Mapleton City Planning Commission Staff Report

Meeting Date: January 14, 2010

REQUEST

Roger Knell, agent for the Corp of Presiding Bishop of the Church of Jesus Christ of Latter Day Saints requests a conditional use permit and project plan approval in order to construct a parking lot on property located generally at 31 West Maple Street. The subject property is located in the A-2 (Agricultural-Residential) Zone.

Attachment #2

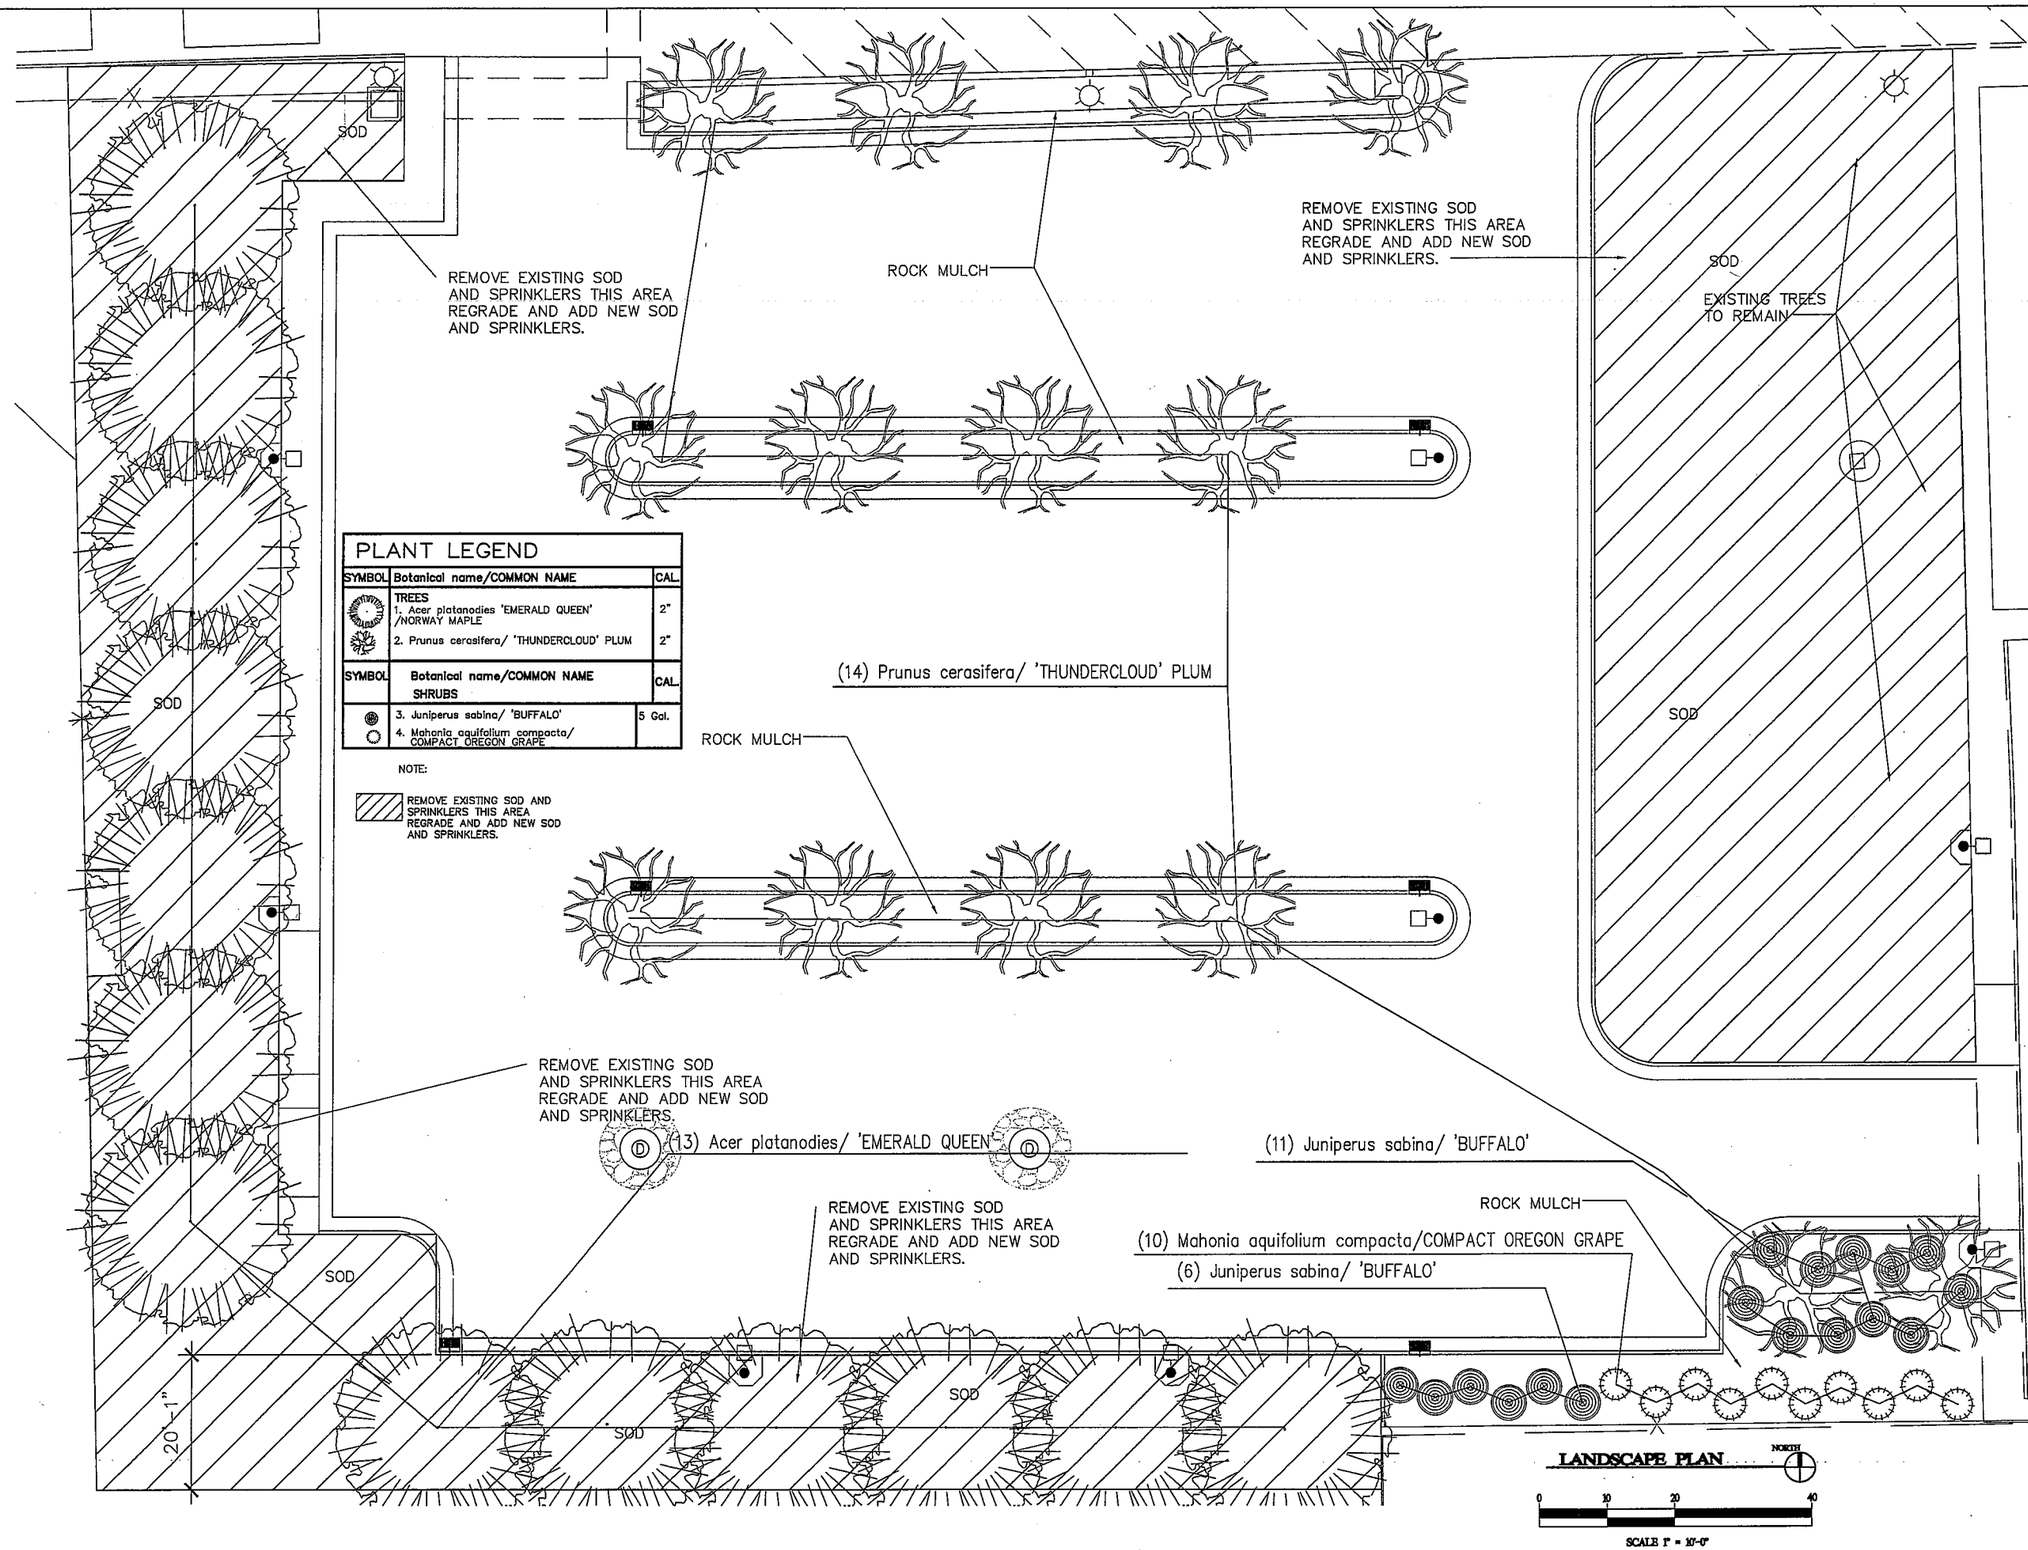
1. The applicant is requesting modifications to the landscaping plan (see Attachment 2 – Proposed Landscaping Plan).
2. Section 17.15.100, Parking Lot Landscaping, Paragraph C1, reads, as follows:

1. Interior parking lot landscaping areas shall be dispersed throughout the parking lot. Landscaped islands shall be required at the end of the parking rows, and at the midpoint of parking rows which exceed ten (10) parking stalls, or every ten (10) stalls if parking rows exceed twenty (20) stalls.

3. As can be seen from the attached proposed landscaping plan, the applicant is proposing to remove the landscaping islands at the end of parking rows and every ten (10) stalls.
4. Section 17.15.020, Landscape Requirements, Paragraph B, reads, as follows:

5. The DRC (Development Review Committee) has no concerns regarding the proposed modifications to the landscaping plan. **STAFF RECOMMENDATION:** Staff recommends Approval of the proposed parking lot with the following conditions: 1. Combined the existing five (5) parcels into one (1). 2. Provide two (2) additional handicap spaces. 3. Parking lot lighting shall be illuminated adequately to prevent direct illumination of adjoining properties. 4. Submit State Storm Water Permit (NOI/NOT/SWPPP). 5. Install a new ADA ramp at the corner of Maple and Main as per APWA. 6. Upgrade all broken/cracked sidewalk, curb, and gutter on Maple Street and Main Street.
